Welcome Break, Hinckley (Land to East of Wolvey Road, Stretton Baskerville)
Lead Local Flood Authority Planning Consultation - Dice Response; Application Ref. R23/1047

Response to Warwickshire County Council Lead Local Flood Authority (LLFA)

PROPOSAL: **Approval of condition 4 (surface water drainage) of R23/1047 (Construction of a motorway service area)**

LOCATION: **Land To East Of, Wolvey Road, Stretton Baskerville**

Rainfall Area Treatment Plan

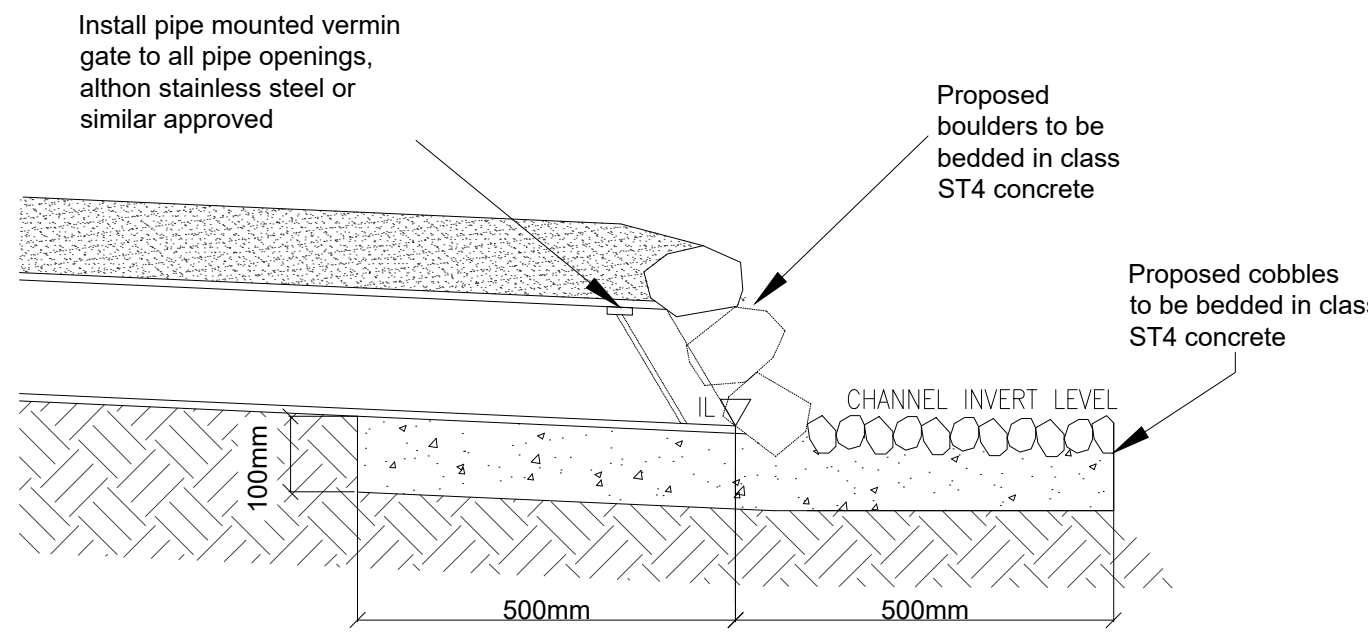
Within the Teams meeting the LLFA officer requested a rainfall area treatment plan to highlight which treatment trains apply to what area. This has been completed and can be found in **Appendix C**. The rain area plan also includes a summary table of what mitigation indices apply to each area both through the initial treatment method and final indices for the outfall flow after polishing treatment via an SDS

Items of further note with reference to the rain area plan:

- Some areas of the HGV parking were not feasible to treat at source through permeable paving or bioretention filtration. This was due to performance requirements for the surfacing against heavy HGV trafficking and suitability for pedestrian footfall from coach parking. This is also constrained by availability of landscaping at a suitable location or size commensurate to the scale of area to be drained. Permeable paving has been provided to enhance the source treatment as much as possible.

- The HGV area and primary access route used by HGVs would be classified as high risk under CIRIA C753, the general parking areas as medium-risk, and roof drainage as low risk. Except for the petrol forecourt roof flows, all areas will meet and exceed the high-risk requirements under CIRIA C753 of **0.8/0.8/0.9** (Total Suspended Solids / Metals / Hydrocarbons).

- With respect to the petrol forecourt roof flows, these would only be treated by the vortex separator, but as the low-risk commercial roof run-off mitigation requirement is only **0.3/0.2/0.05**, the vortex separator will provide indices in excess of x2 the minimum requirement.

- Small areas in proximity to the petrol forecourts will discharge to foul. This is forced by requirements to provide cut-off drains for petrol spills. These flows will be treated by a Class 1 full retention separator. Following manufacturer guidance, we have designed in a limited rainfall area to drain into this catchment. Fresh water must be provided to maintain correct function (ie. must not dry out) and avoid stagnant water within the tank.

Rain Garden Construction Detail

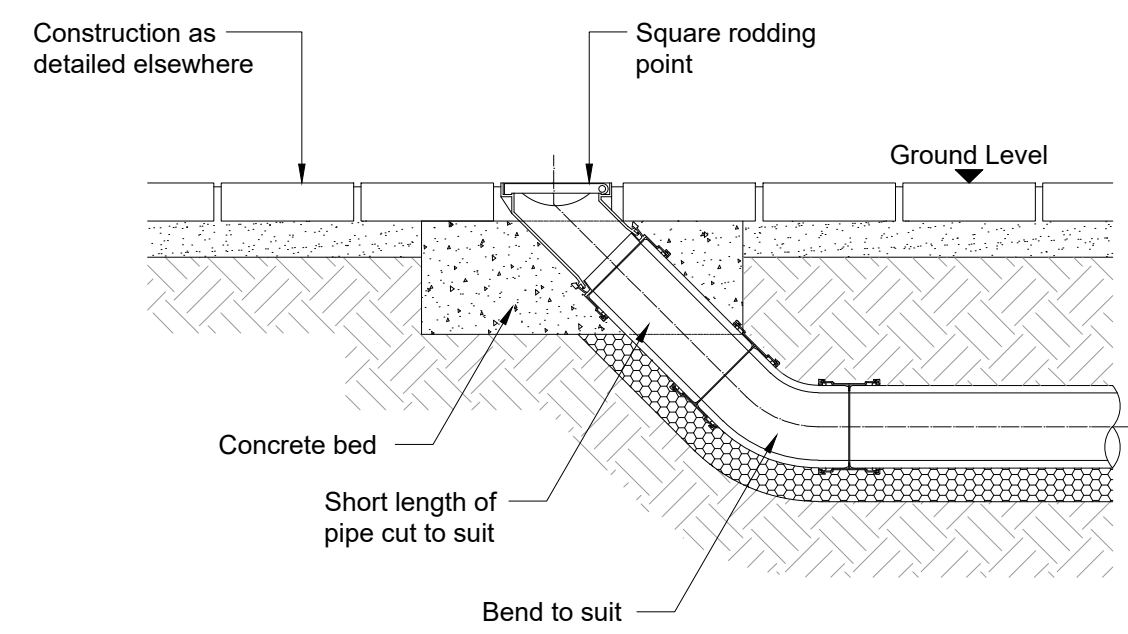
o The cross section drawing provided shows upstand kerbs surrounding the rain gardens and does not indicate an inlet whereby run-off can enter the rain gardens. The LLFA requires further information as to how these features will provide attenuation and water quality benefit to the drainage scheme.

- The cross section drawing provided shows upstand kerbs surrounding the rain gardens and does not indicate an inlet whereby run-off can enter the rain gardens. The LLFA requires further information as to how these features will provide attenuation and water quality benefit to the drainage scheme.

The raingarden and permeable paving details show clearly how these features collect and distribute, and that they are capable of treating through flows (via filtration media). To address a specific LLFA note given, the raingarden has been provided with an overflow gully to bypass treatment in exceedance events.

The raingardens have been designed within the construction details to function as bioretention. It was not feasible to design to a standard CIRIA C753 bioretention detail, due to the difficulty (primarily safety issues – ie. lack of pedestrian protection) of allowing an overland flow route from carriageway into raingardens. Therefore, a bespoke detail has been proposed providing the core CIRIA

requirements of 400mm depth of suitable filter media, separation geotextiles, an overflow facility, and maintenance access.

On specific overflow mechanisms, as previously outlined, the rain gardens are provided with an overflow gully, shown on the construction details drawing (**Appendix D**).

Permeable Parking Underdrainage Indicative Construction Detail

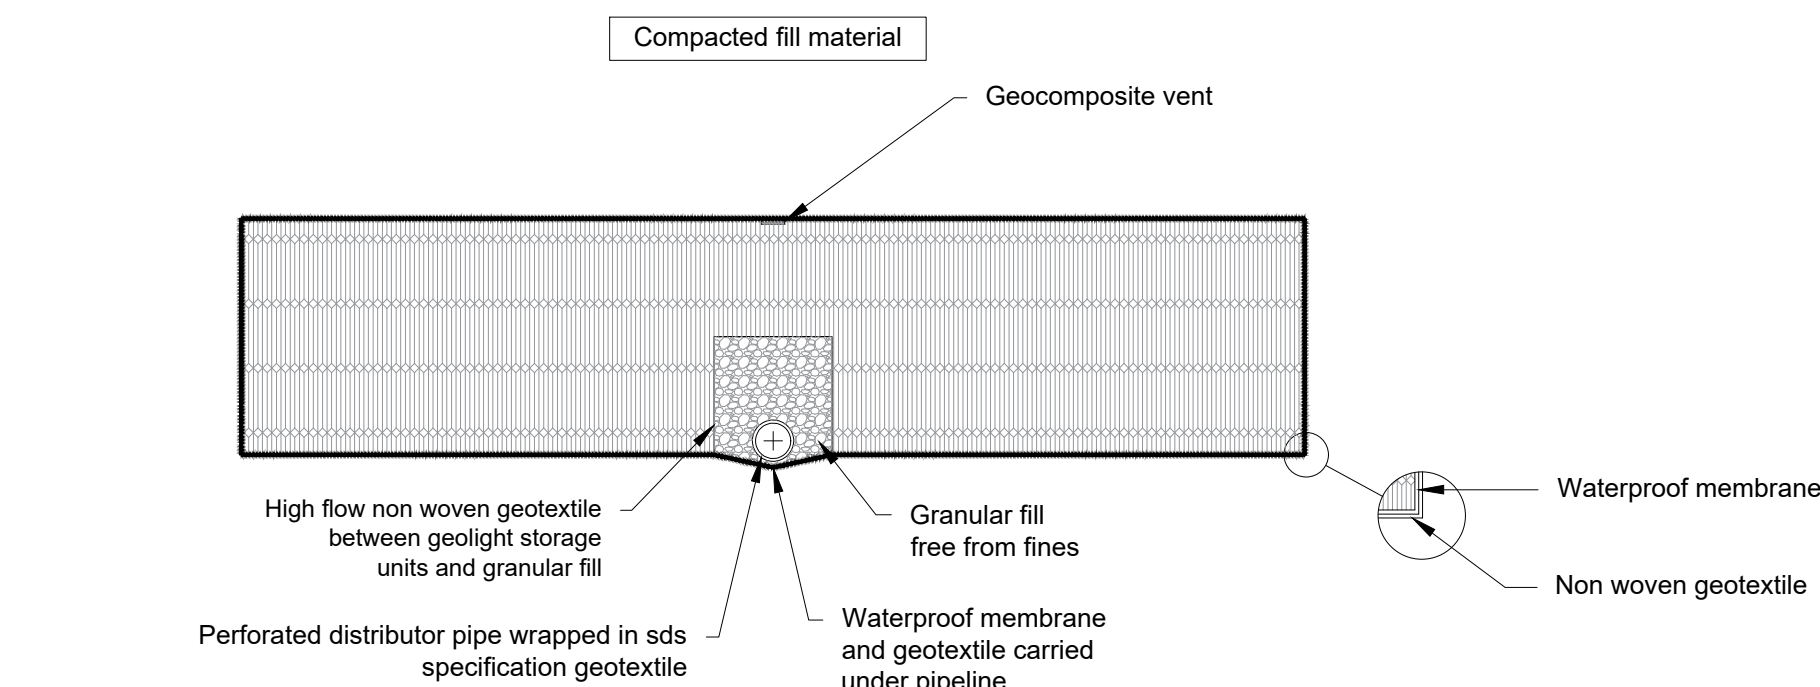
2. Provide standard details and detailed cross section drawings for all drainage features associated with the scheme as per point 5 of condition 4. At the detailed design stage drawings should be approaching a level of detail suitable to instruct tender or construction.
